**PCD-ENGINEERING REVIEW COMMENTS  
IN BLUE BOXES WITH BLUE TEXT**

# **FINAL DESIGN REPORT FOR SAND CREEK RESTORATION**

October 21, 2021

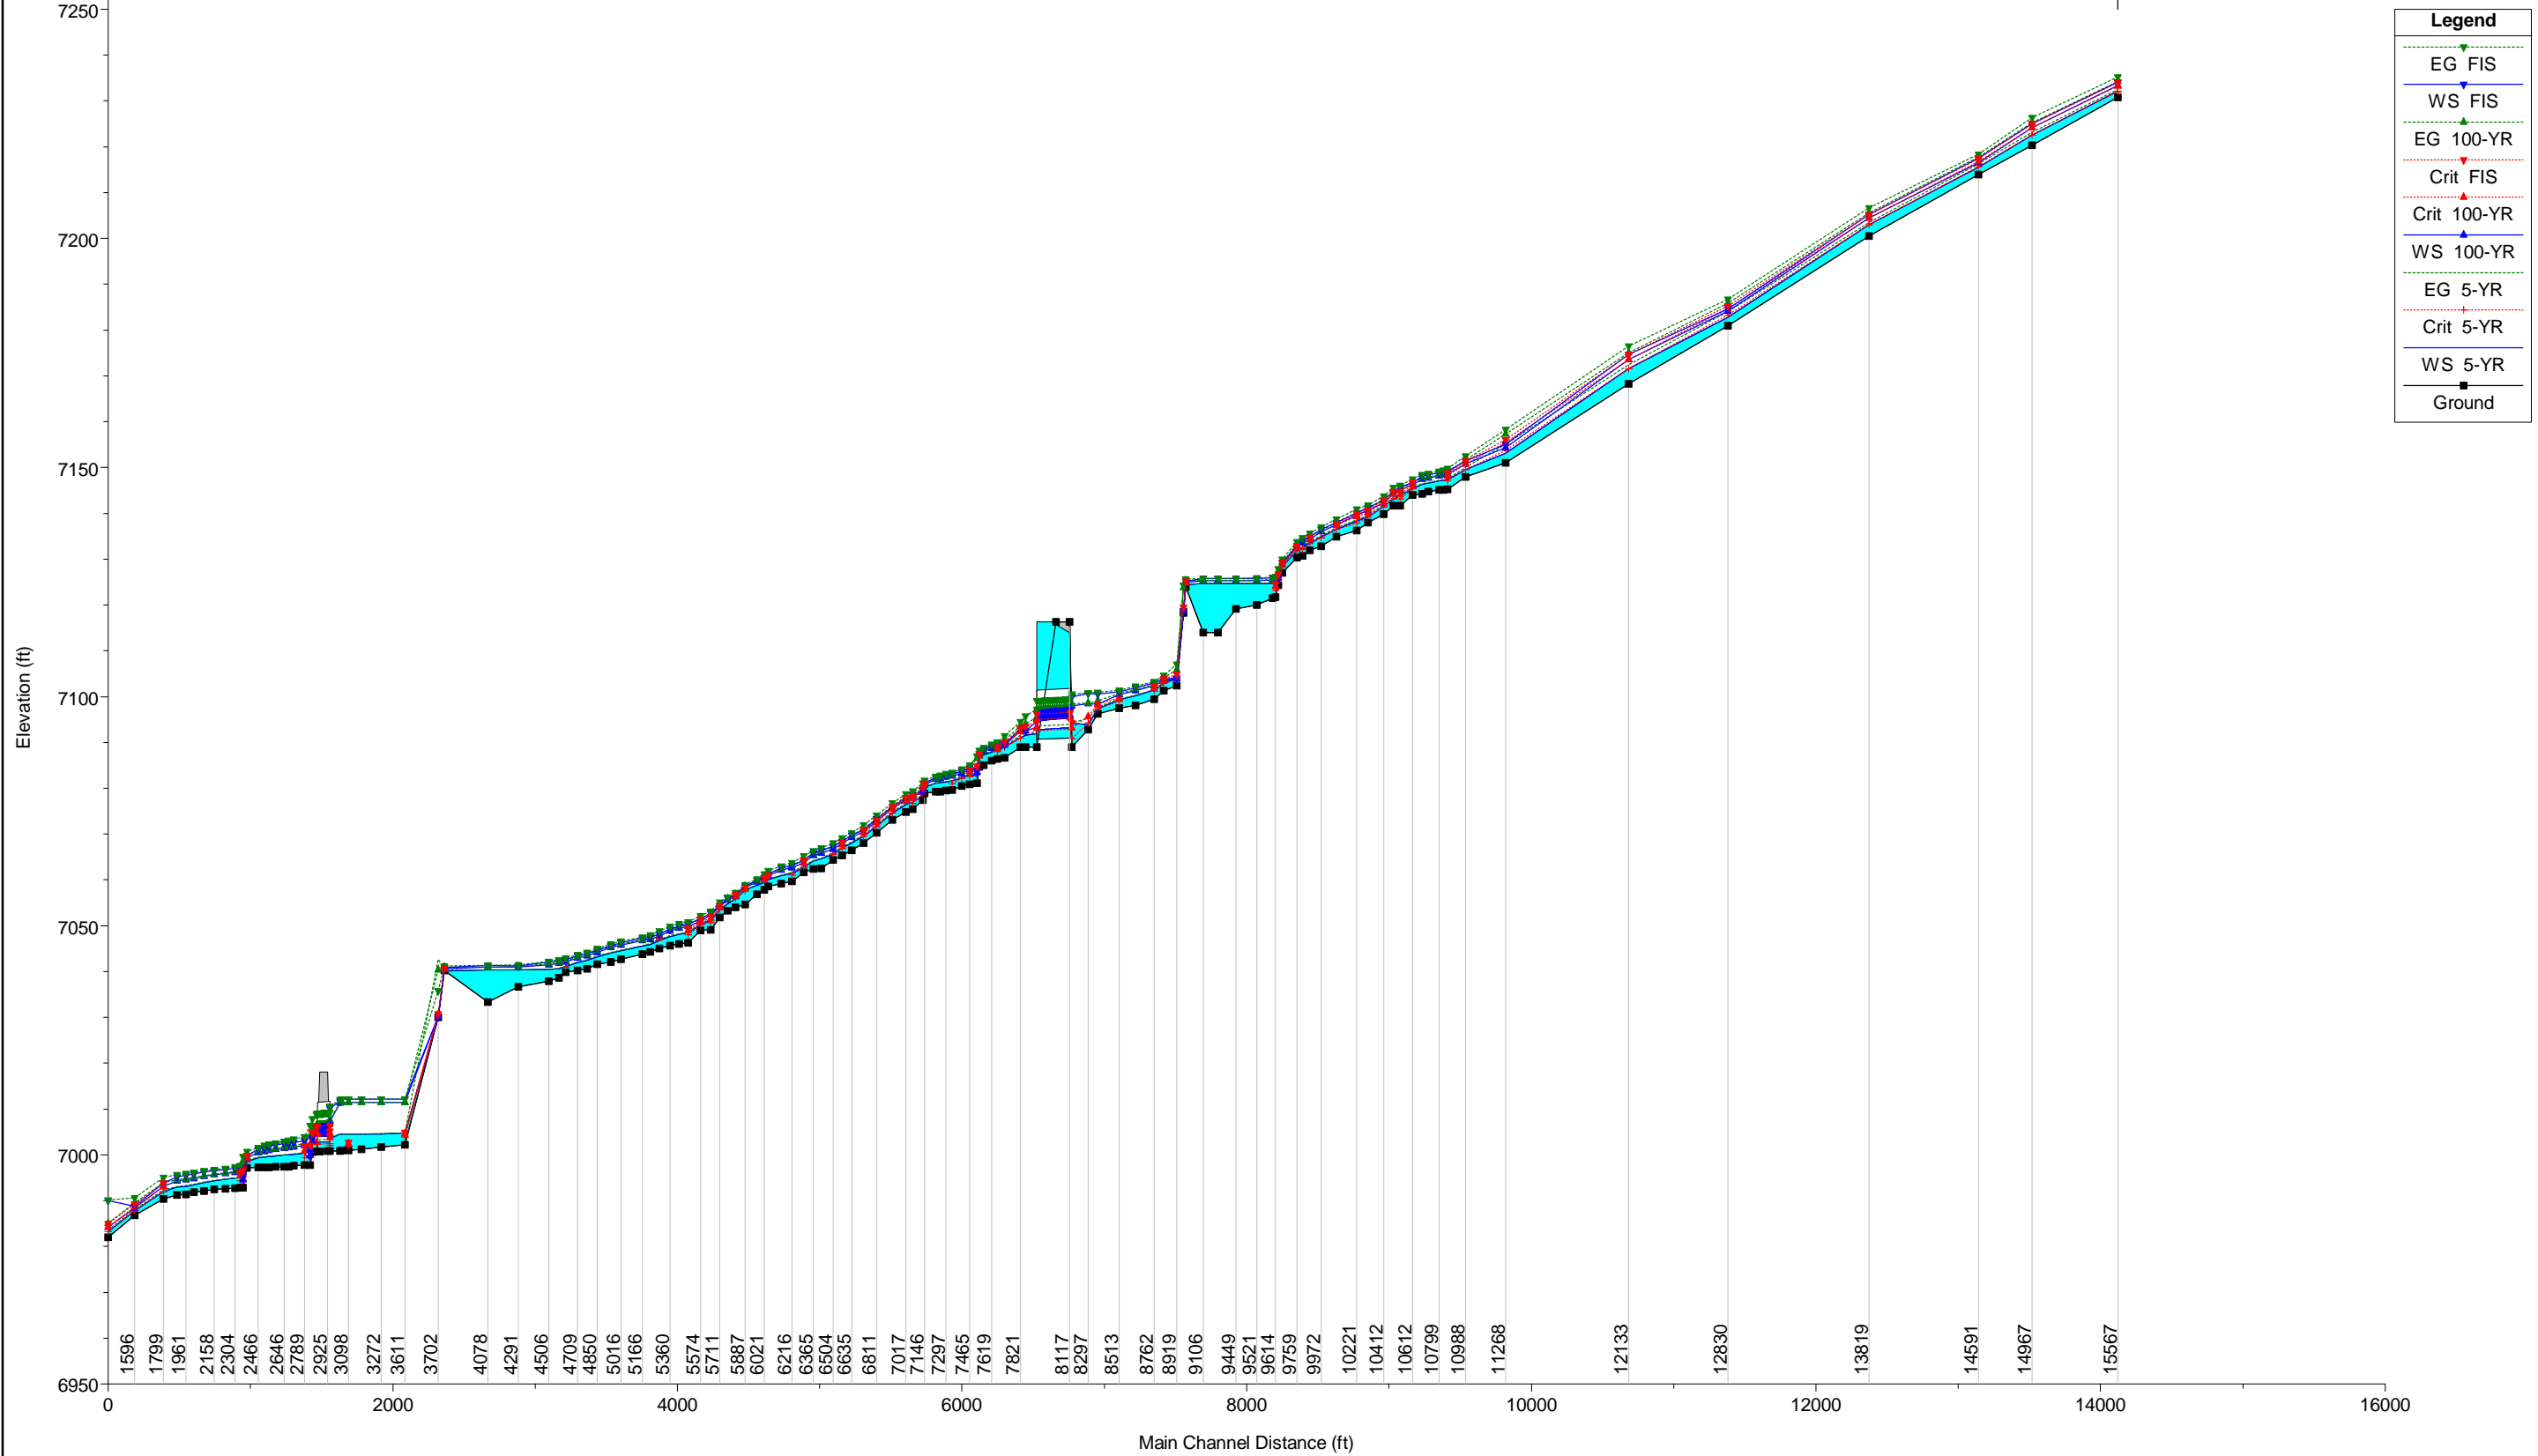
Add check structure near S property line?

Not checked with this review
